Planning Statement

BANK FARM, HIGHER LANES, HIGHER
WYCH, WHITCHURCH, SY13 3AX

April 2024

'Works to widen and increase the height of the lean-to to rear of farmhouse along with rebuilding and change of use of piggery building to provide ancillary residential accommodation including glazed recessed linkway and hard landscaping (Part Retrospective)'.

DRAWING 22-141c **REV**

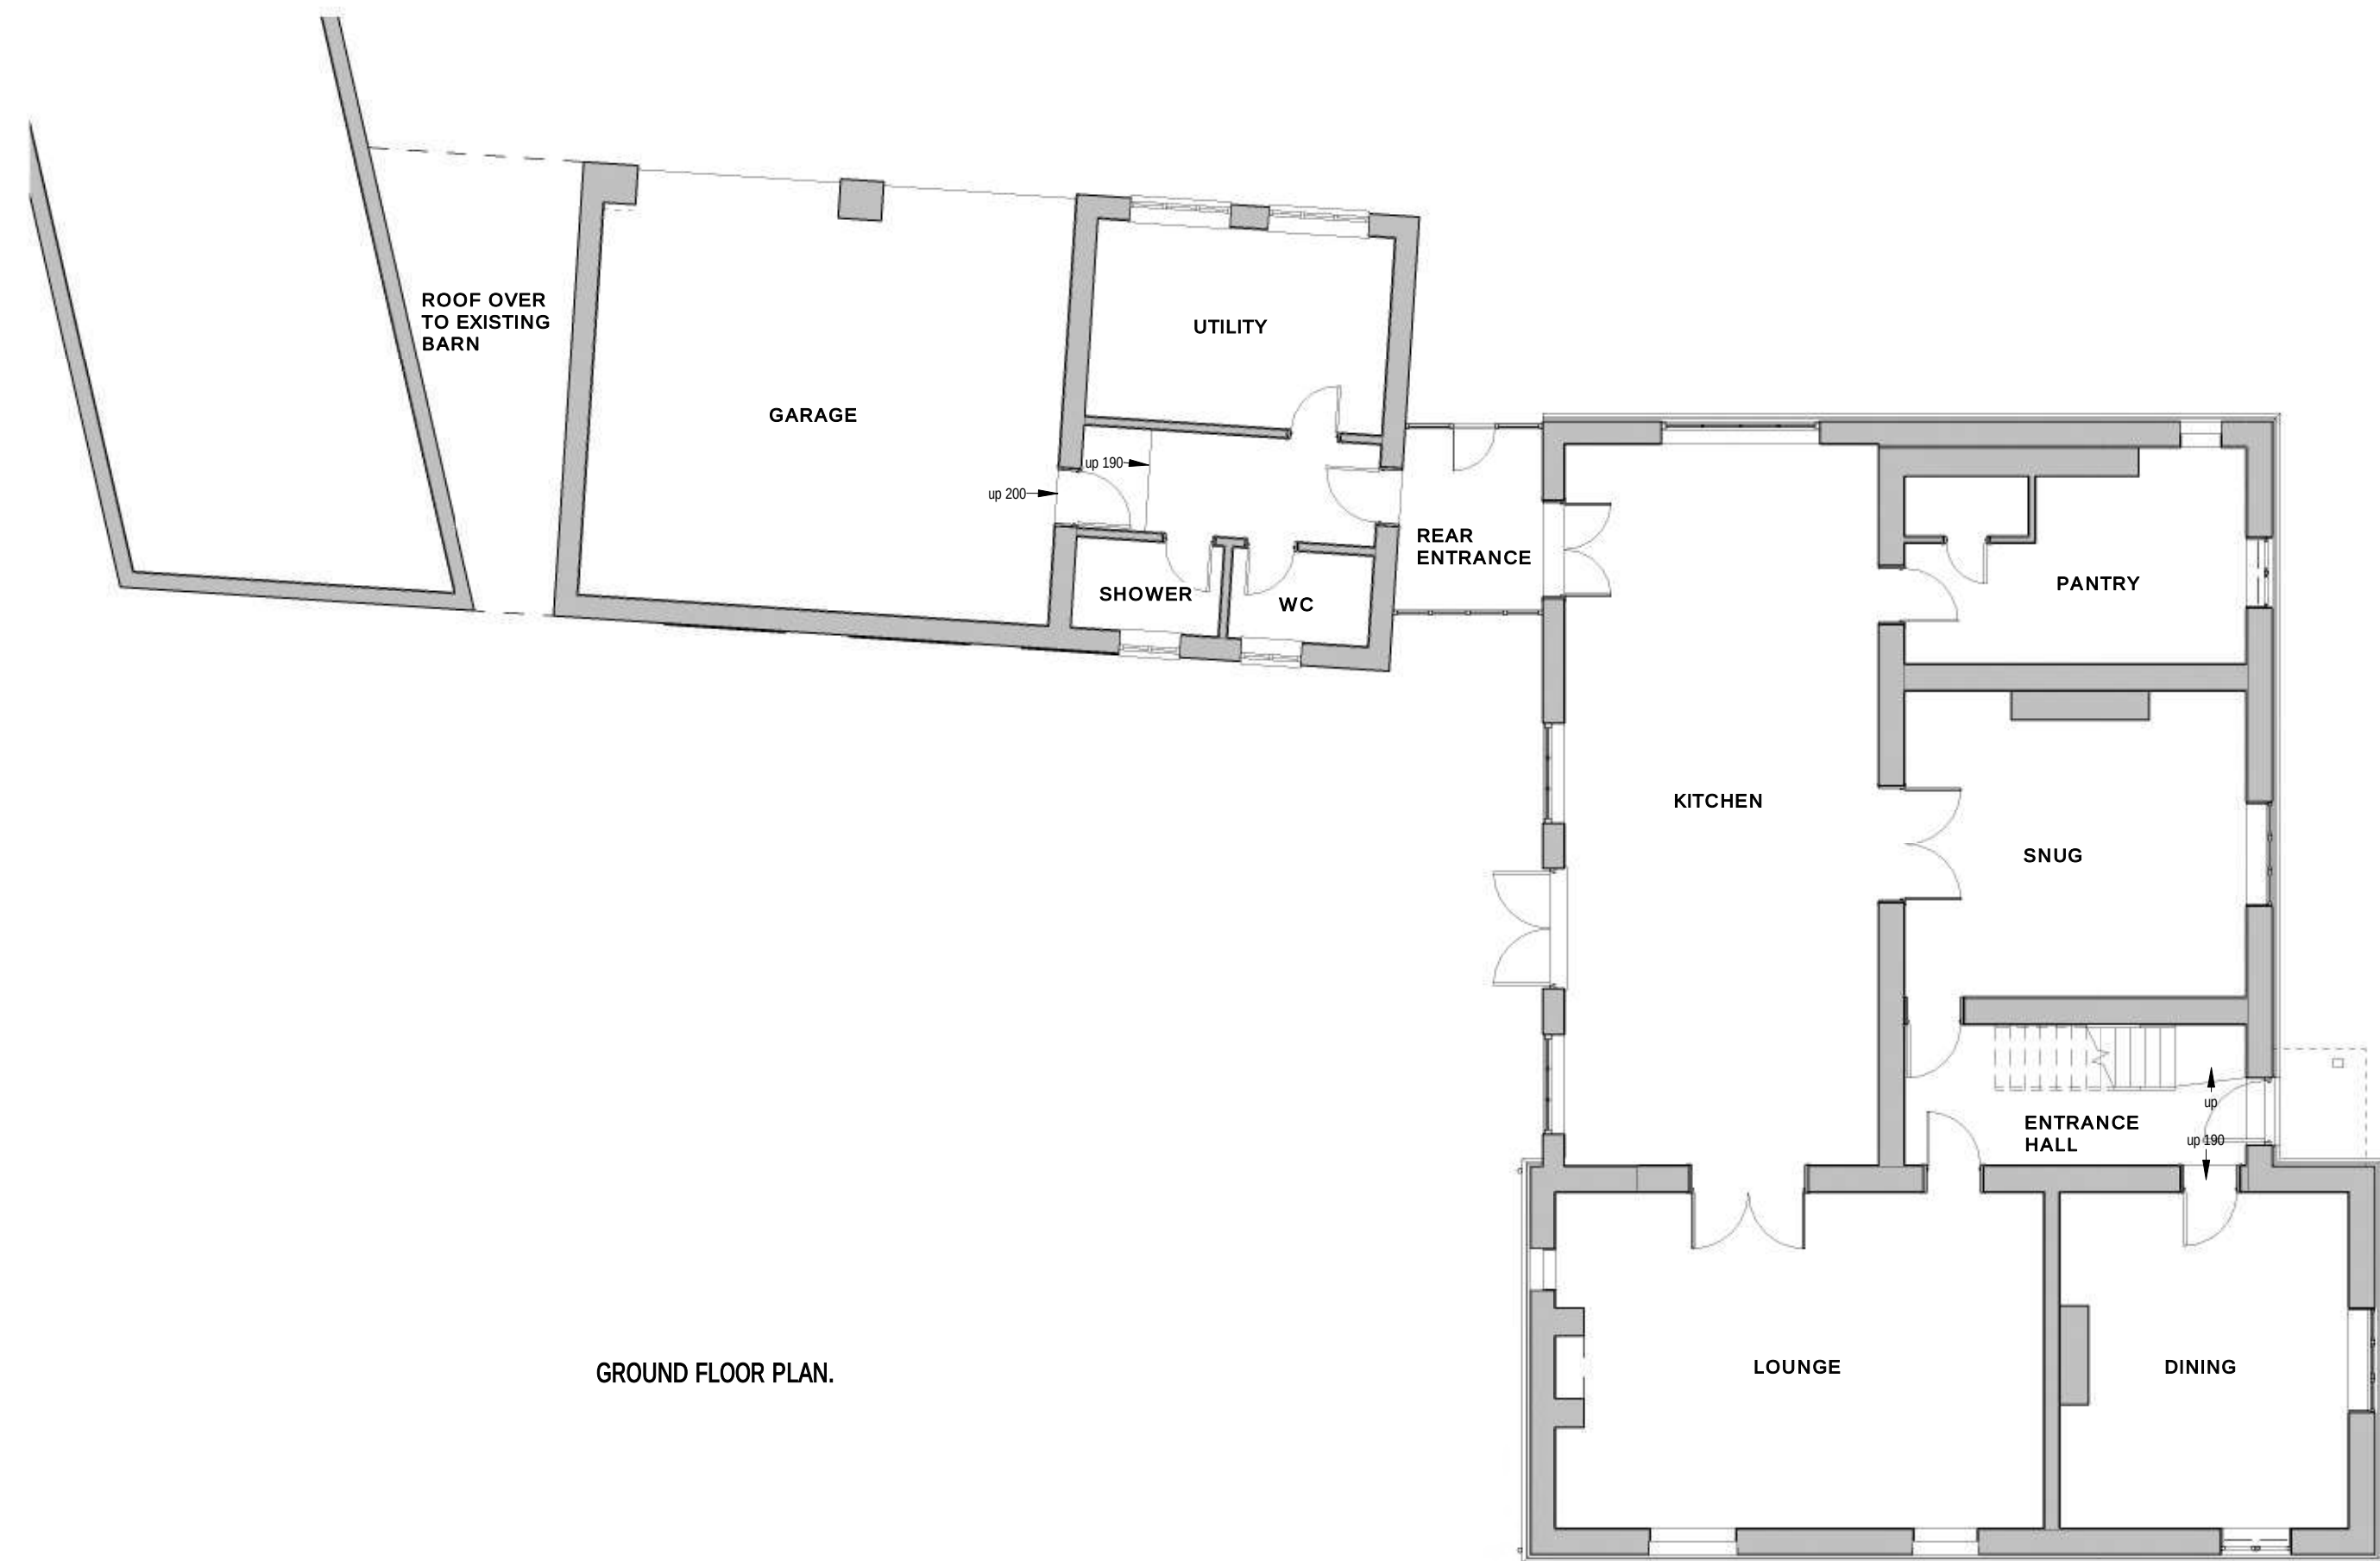
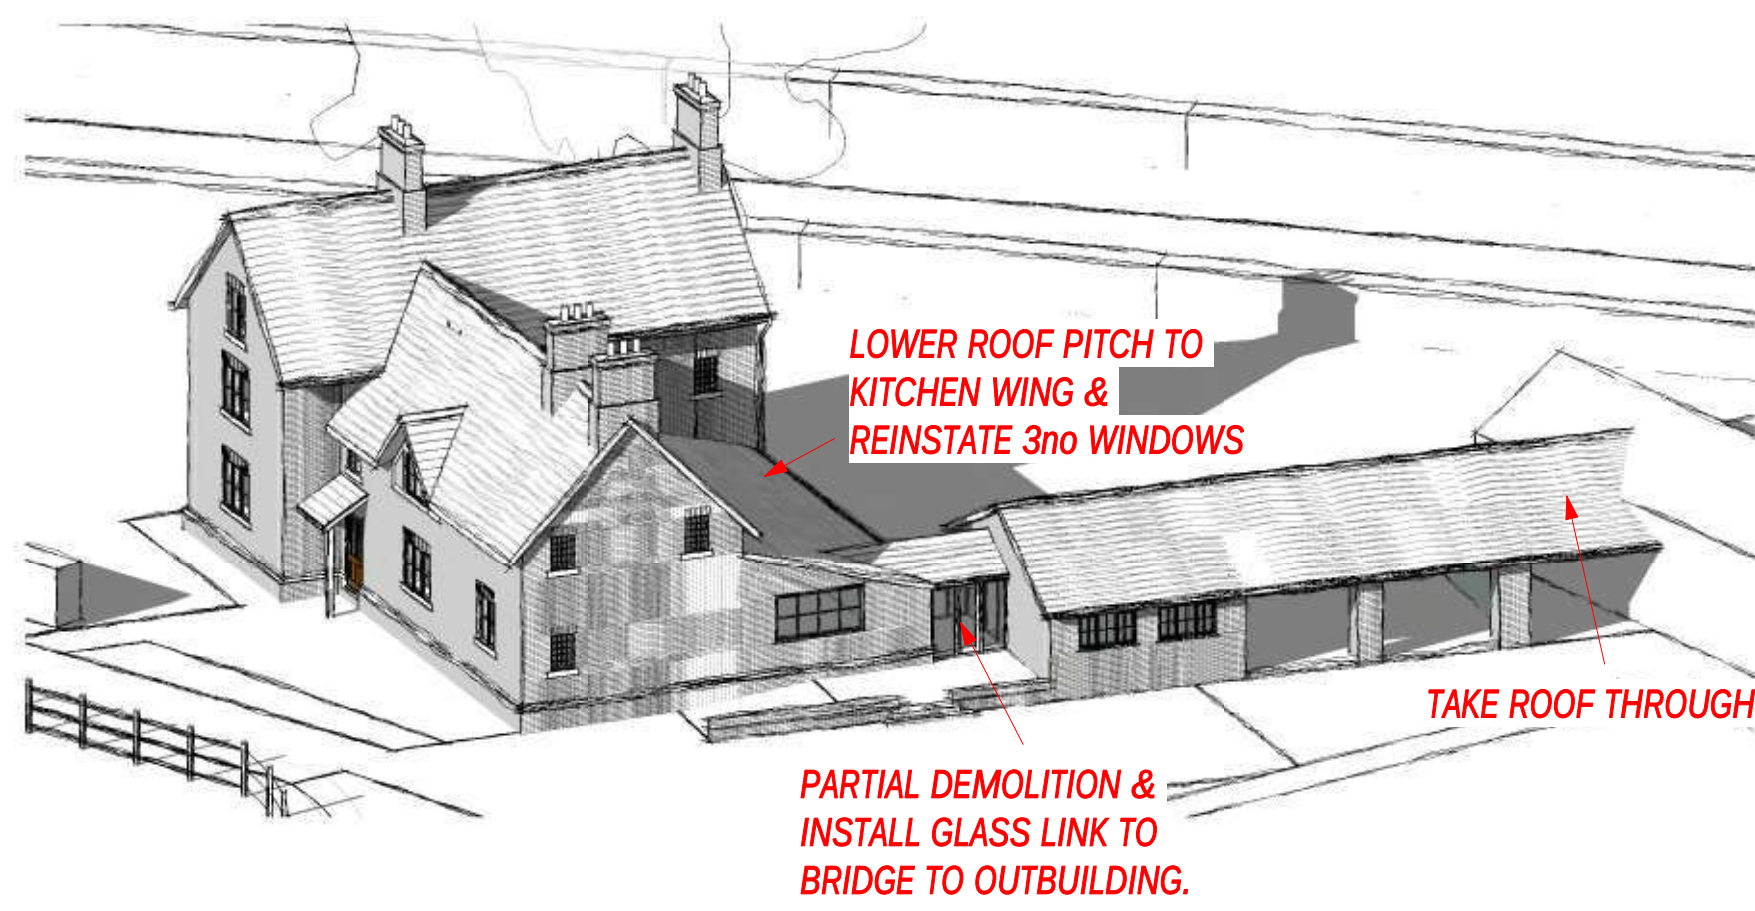
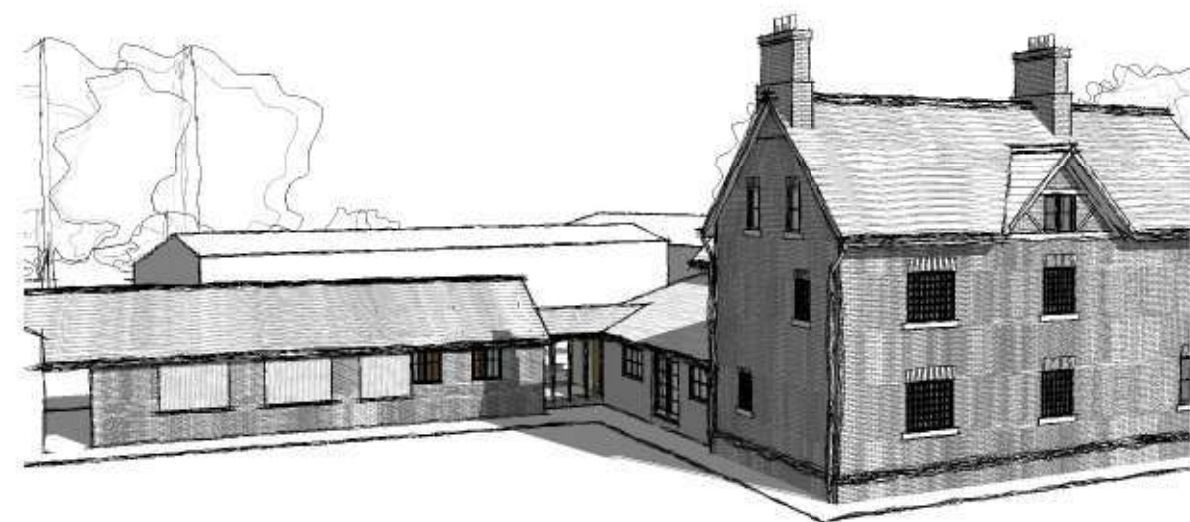
- 4.21 A cat slide roof is currently evident on the extension (see Drawing 22-141c) and it is proposed to retain this in line with the Pre-Application advice contained in Appendix 2. It was felt that a lower pitch roof would create awkward details. LPGN20 (House Extensions) states that an extension should be subservient to the main property and therefore the development accords with this policy.

- 4.22 A window has also been installed on the rear elevation (see drawing 22-141c) to provide more natural light into the extension as well as providing improved natural surveillance at the property in line with the requirements of GDP1 and TAN 12. As well as this, French style double doors and 2 No. windows have
